Access Compliance Report Public Rights-of-Way (Curb Ramps)

Main Street: LOWER_LAKE_DR Cross Street: LAKE_COURT_DR Location: NE

ADA ID: RPRK211014112739 Ramp Type: Type 1 - Perpendicular Diagonal Initial Pass/Fail: Fail Overall Compliance: No Severity Score: 15

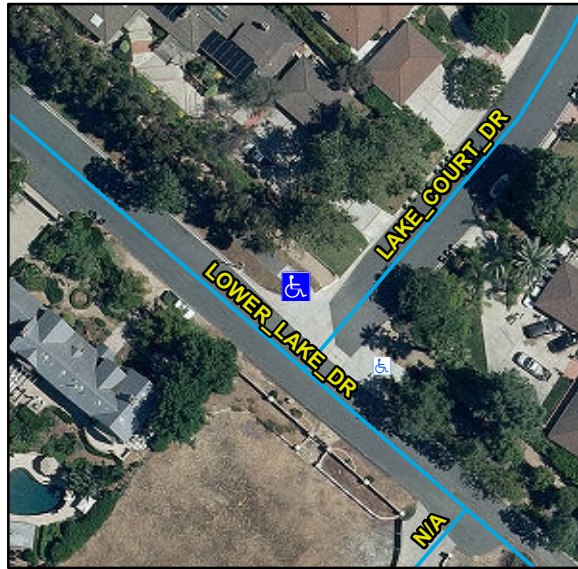
Compliance	Description	Data	Compliance	Description	Data
N/A	Ramp Length (in)	82	N/A	Flare Type LT	
Yes	Ramp Width (in)	48			N/A
No	Ramp Run Slope (%)	9.9	N/A	Flare Slope LT (%)	N/A
Yes	Ramp Cross Slope (%)	3.9	N/A	Flare Traversable LT	N/A
N/A	Landing Present	N/A	N/A	Flare Type RT	
N/A	Landing Length (in)	N/A			N/A
N/A	Landing Width (in)	N/A	N/A	Flare Slope RT (%)	N/A
N/A	Landing Run Slope (%)	N/A	N/A	Flare Traversable RT	N/A
N/A	Landing Cross Slope (%)	N/A	N/A	DWS Provided	N/A
N/A	Landing Movement Obstructed?	N/A	N/A	DWS Contrast	N/A
	Landing Movement Type	N/A	N/A	DWS Length (in)	N/A
N/A	Landing Shared	N/A	N/A	DWS Full Width	N/A
N/A	Clear Space	Yes	N/A	DWS Offset Left (in)	N/A
N/A	Clear Space To Crosswalk (in)	N/A	N/A	DWS Offset Right (in)	N/A
N/A	Marked Crosswalk 1	No	N/A	Marked Crosswalk 2	No
	Crossing 1 Direction	SW		Crossing 2 Direction	SE
	Marked Crosswalk 1 Width (in)	N/A		Marked Crosswalk 2 Width (in)	N/A

Remove & Replace Curb Ramp With Two New Directional Ramps or Equivalent.

R304.2.2, STD 1115
